M4/M5 Link

Urban Design Assessment

Prepared for
NSW Department of Planning & Environment

Issued
17 November 2017

Spatial Comparison, Page 25 of Urban Design Report, EIS, Vol 2F,

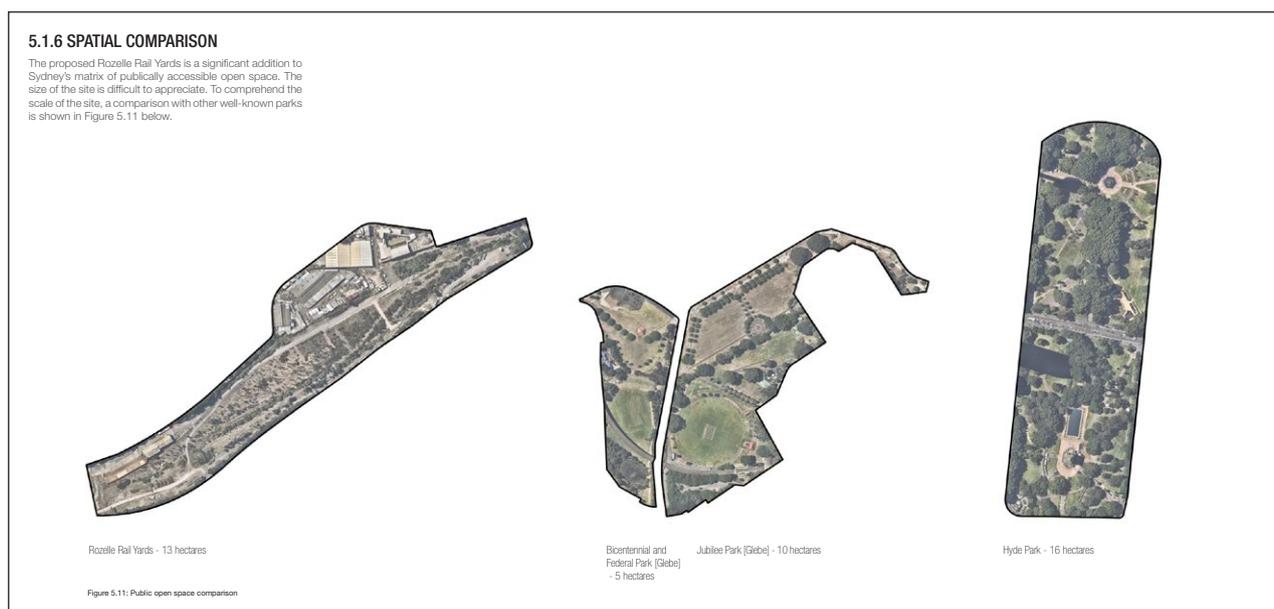
Whilst the spatial comparison is helpful, it would benefit from some further interrogation. Specifically, comparing areas of passive and active spaces and amenities being provided across the various examples. For example, while Hyde Park succeeds in providing a significant amount of passive open space, there is virtually no active recreation provided due to the formal nature of the space. Prince Alfred Park near Central Station is a significant inner-city public open space that provides both active and space areas, including a public swimming pool, and may have been a more suitable comparison.

Further analysis of park uses would allow the public to gain an even stronger comprehension for the types of amenities that could be accommodated at Rozelle. Furthermore, it would allow them to consider what types of facilities could address crucial needs for the local area, which may alleviate their concerns.

Masterplan Commentary

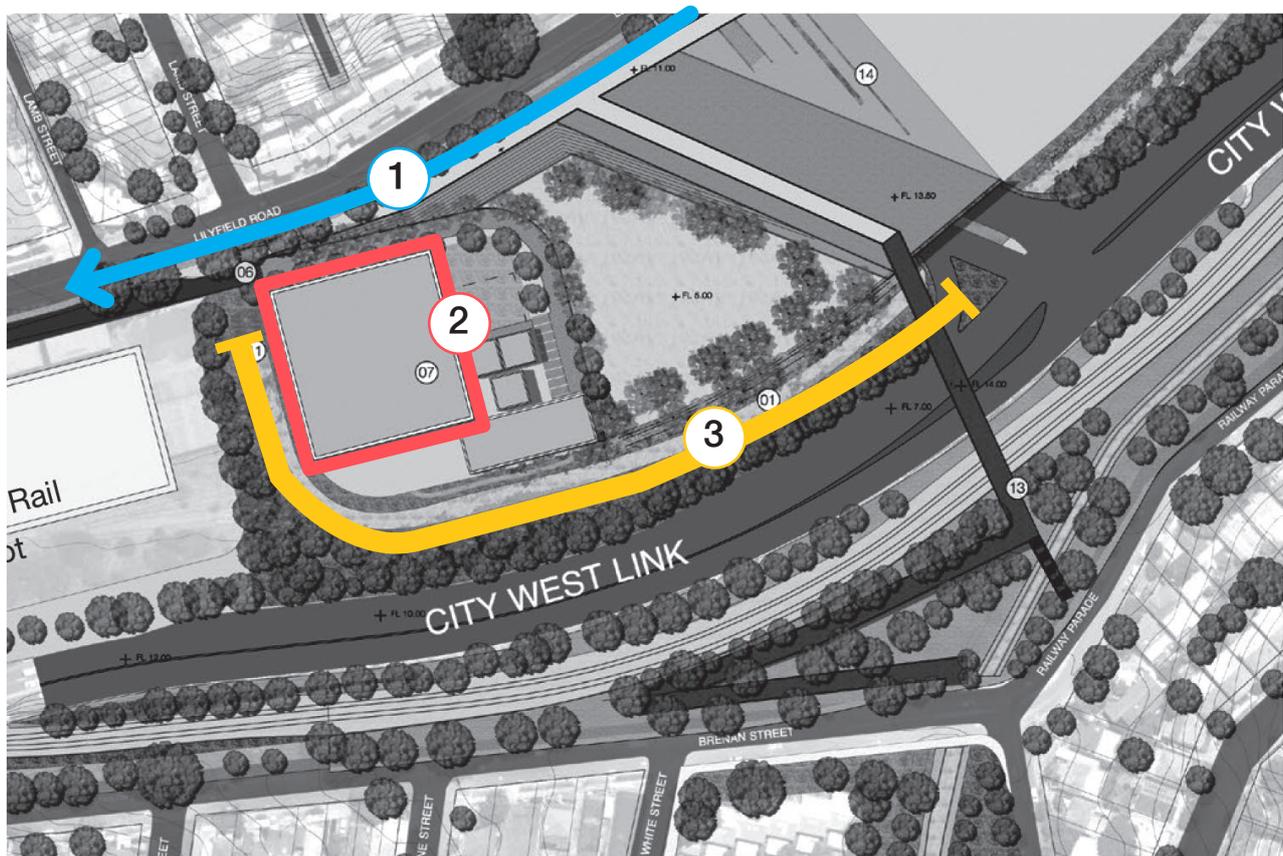
1. What is the extent of works to Lilyfield Road, along both frontages, proposed as part of delivering the masterplan?

3. The open body of water that runs along the southern edge of the site has the potential to be an amazing feature of the site and draw for visitors. Further information to be provided as part of the next design stage; addressing safety, access, integration with the WSUd Strategy

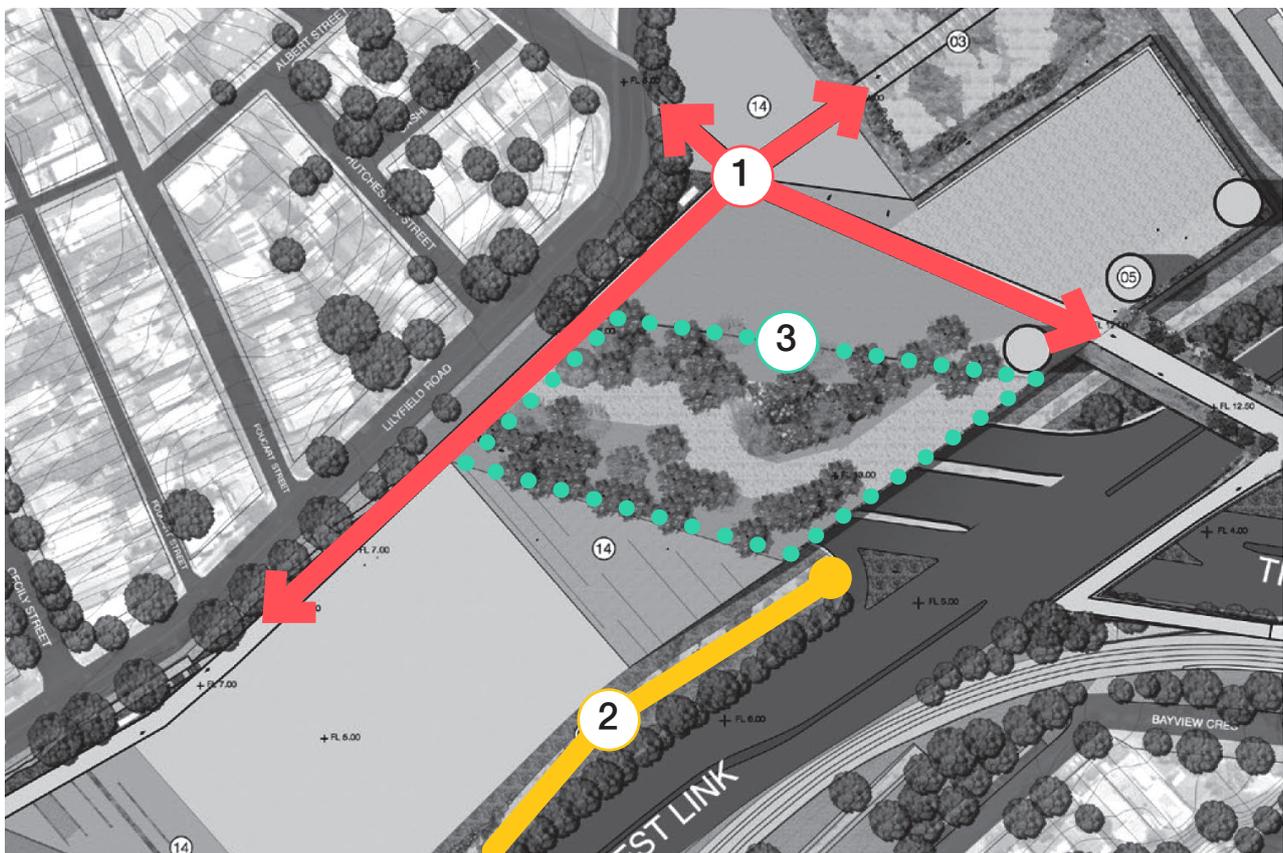
1. Key pedestrian connections have been rationalised for the exhibited masterplan, however, a finer grain of pedestrian connectivity throughout the park should be addressed in the next design phase - connecting key spaces, facilities and reflecting potential 'desire lines'
2. Pedestrian route along the northern frontage of the City West Link stops at the portal, with no indication of pedestrian crossing at this point - this is assumed.
3. The matter of planting over the top of the portal has been discussed and its been assured that adequate soil depths and structure are provided to enable mature trees to be established.

1. Footpath appears to end at City West Link with no indication of a pedestrian crossing point. Given the pedestrian bridge is a short distance to the south-west, a crossing point at-grade may be difficult to justify.
2. Amenities block and skate park have been replaced with grassed area. Three ventilation stacks have been indicated on the plan, and are subject to further assessment below.
3. There is little information on this space, what function it serves in the WSUD concept, and whether the water will be sitting there all year round. To be addressed in greater detail as part of the next design phase.
4. No information on the Water Treatment Plant, what it might look like, its scale and presence within the landscape. Also, can vehicles access the surface car parking from the Motorway as the left-hand turn appears very tight, and no dedicated lane is provided.

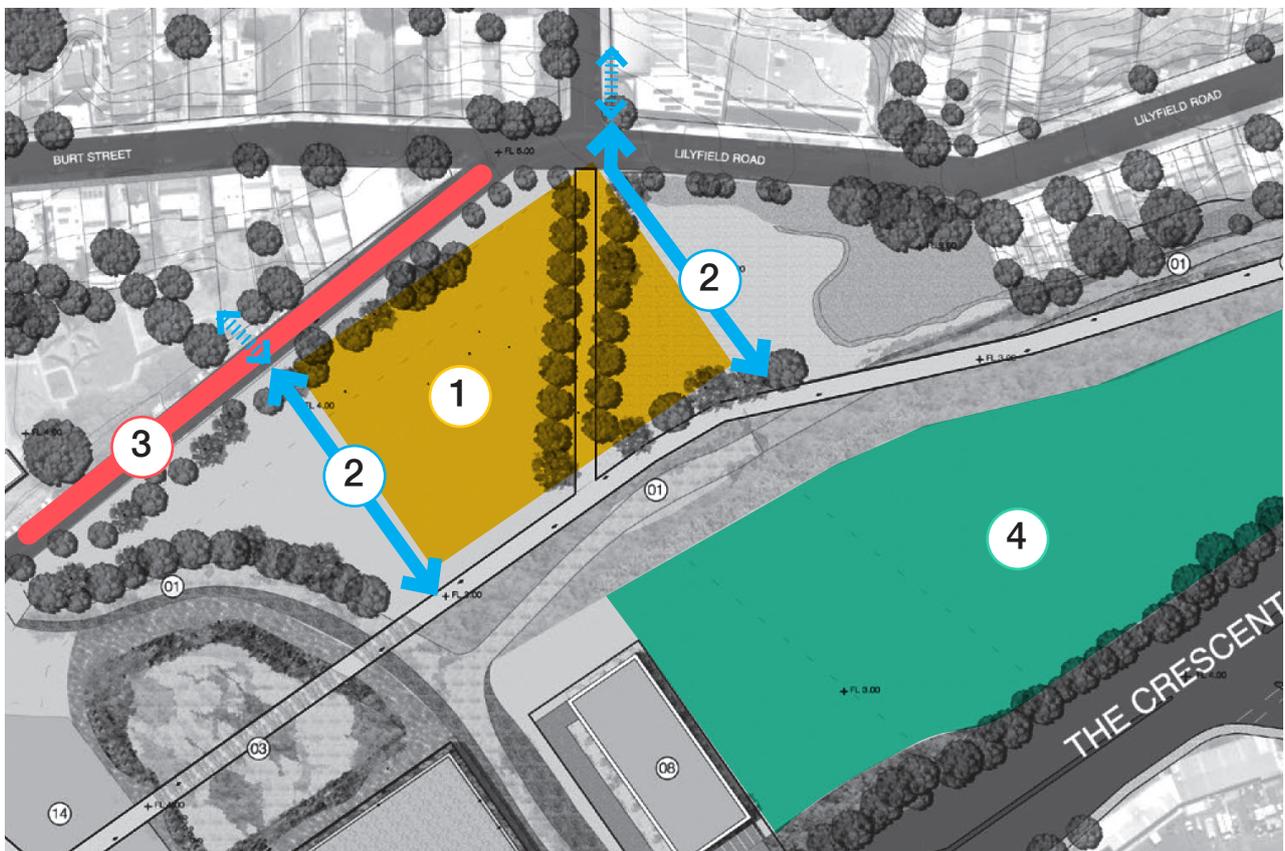
1. EIS seeks to maintain maximum flexibility in the masterplan, presenting a number of alternate uses on this portion of the site (sports fields, passive landscape and a school)
2. Site access from the existing street network to the north remain flexible and be subject to further analysis and confirmation of uses (1)
3. Parking along the Lilyfield Road frontage to support the uses and activities proposed for the site - to be addressed at the next design phase.
4. Previous proposal for a 'garden' in this location has been replaced with a vacant space. Subject to further information and detailed design.

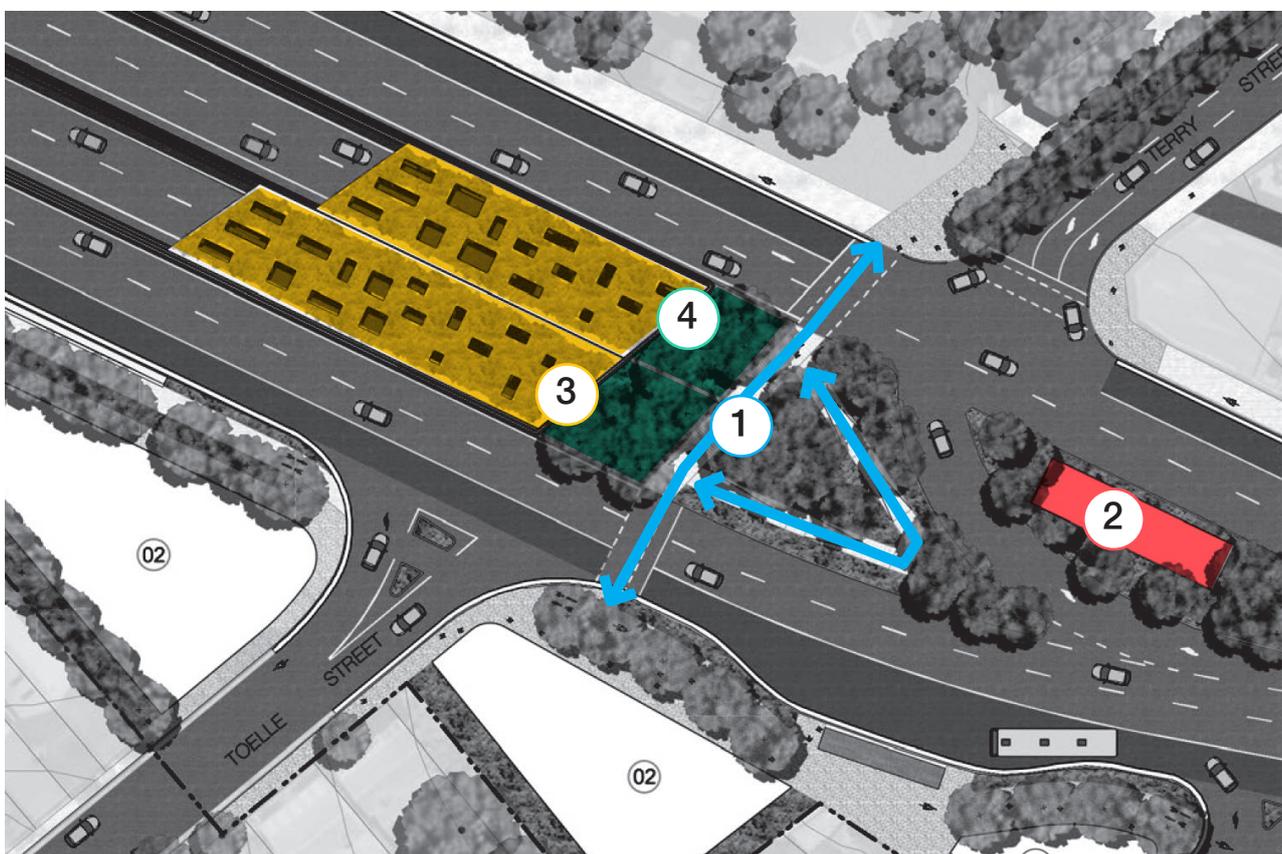
3. The closure of Clubb Street has the potential to increase the quantum and continuity of the open space. The masterplan shows indicates a shared zone at this point, but little information on the potential conflict with pedestrians and cyclist.

1. The Victoria Road island site has been rationalised to include pedestrian connectivity between Toelle and Terry Streets, with supporting landscaping. A pedestrian ramp is proposed to negotiate the change in levels in an equitable manner. Further detail on the safety, lighting and quality of this space is to be provided in the next stage
2. Ventilation facility is proposed within the island, created by the traffic turning lane. The scale and volume of this facility is illustrated in the visual assessment - addressed in greater detail below.
3. Portal design to be finalised in the next phase. Masterplan includes a safety fences along the eastern edge of the portal to stop pedestrians walk on to the structure.
4. Its assumed that mature trees can be established on the roof of the tunnel. Sections indicating soil depth at this location have been removed from the exhibited report.

Figure 13-28 Existing view looking north from Rozelle Bay light rail stop to the Rozelle Rail Yards (R7)

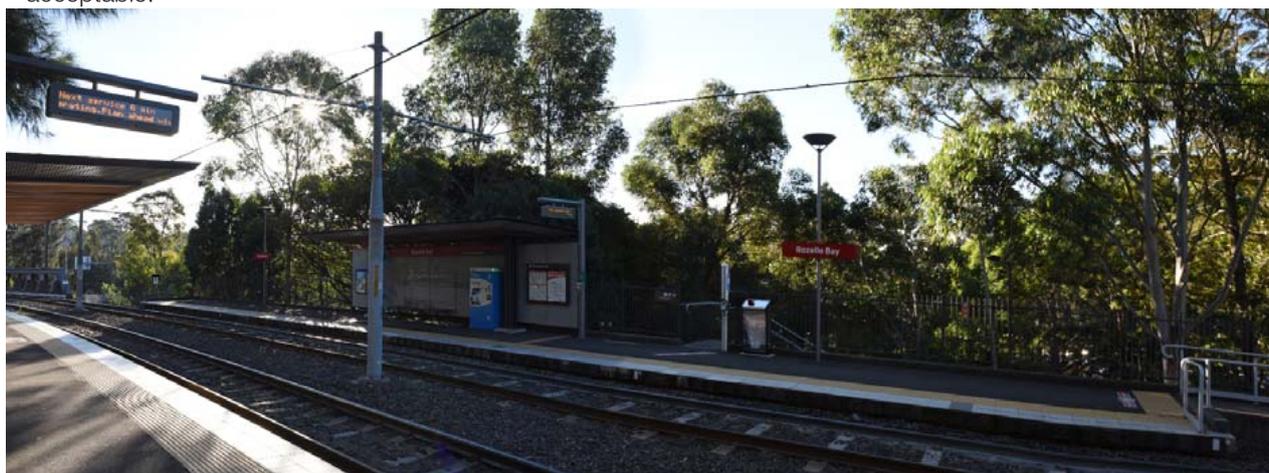
- The removal of the existing vegetation at the Light Rail stop has the greatest impact, as it reveals the long distance views to the Rozelle Interchange, which includes the three stacks that create a new skyline that extends to the Anzac Bridge in the right of the image.
- A positive outcome arising from the removal of the existing vegetation is the visual connection between the station and the new open space
- Regardless of the detailed design of the stacks and the public open space, the impact on this view is acceptable.
